CITY OF ALBUQUERQUE

Re: Christina Kent Day Care
205 Coal Ave SW
30-Day Temporary Certificate of Occupancy
Transportation Development Final Inspection
Architect's Stamp dated 01-14-25 (K14-D234)
Certification dated 08-13-2025
TRANS-2025-00220

RE: Traffic Certification Letter for Christina Kent Daycare

A1 TRAFFIC CIRCULATION LAYOUT
SCALE: 1" = 10'-0"

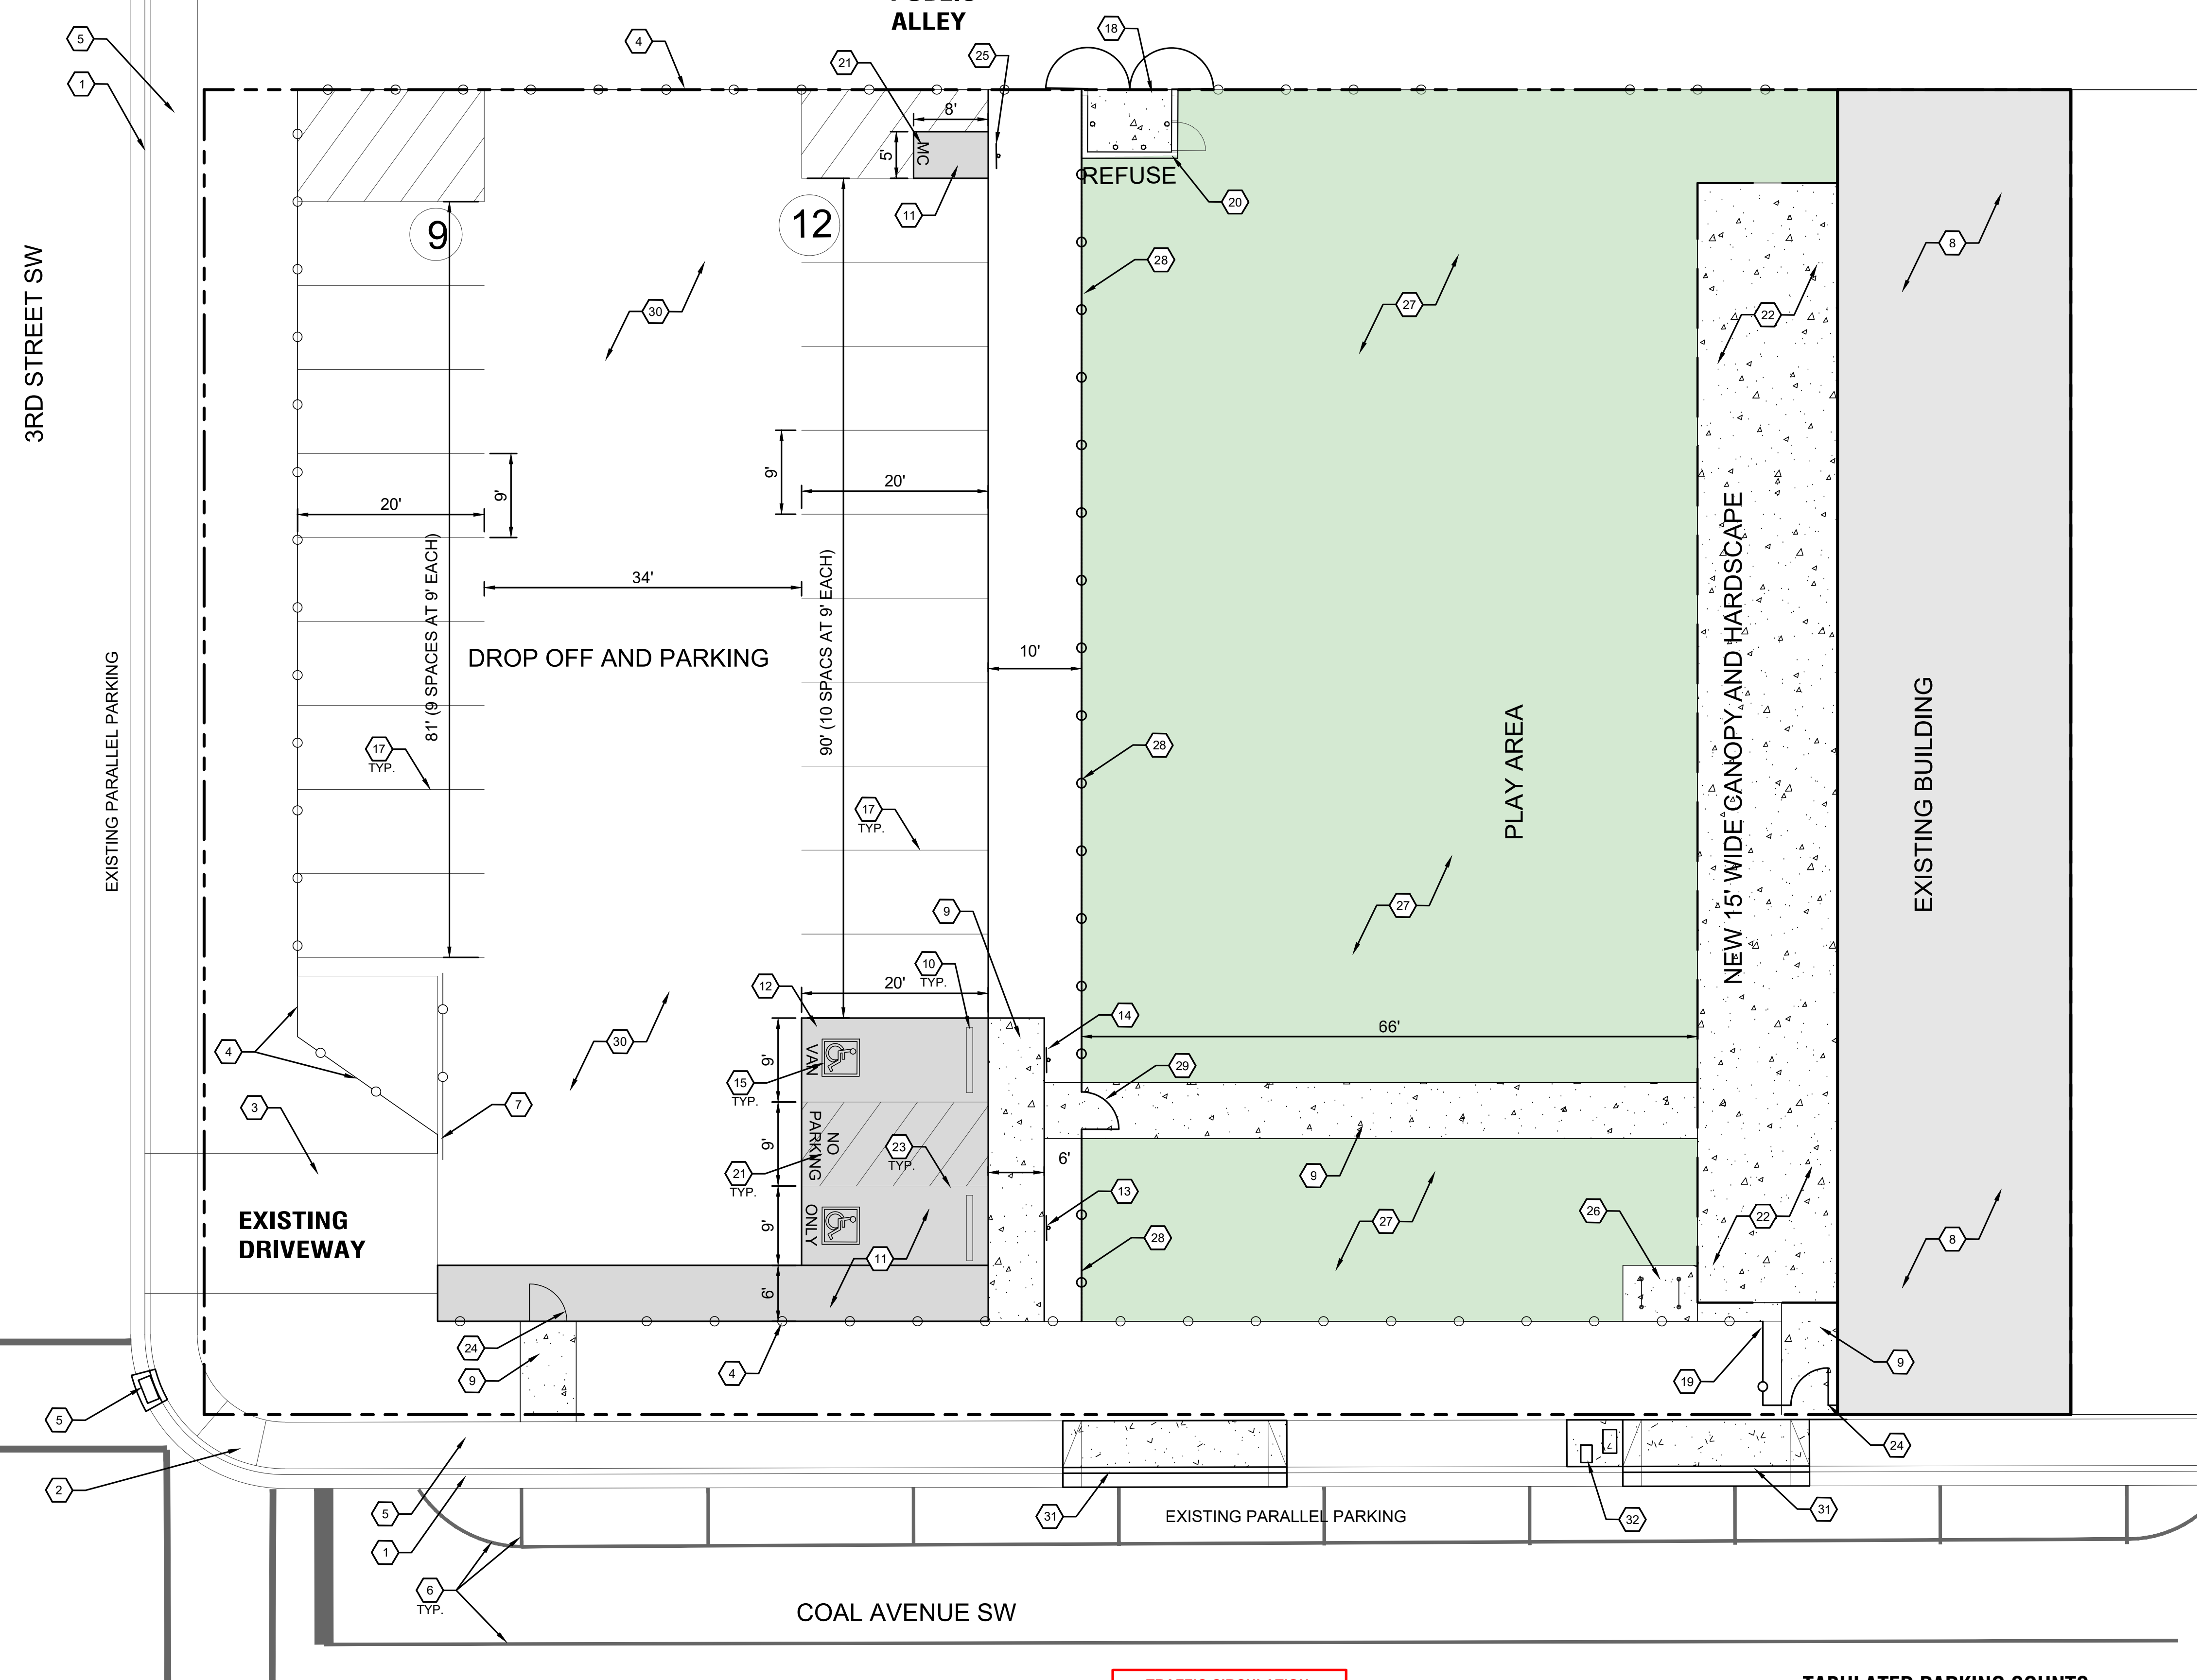
1. Anchor down bike rack.
2. Per the City requirements and approved site plan, All broken or cracked sidewalk must be replaced with sidewalk and curb & gutter.
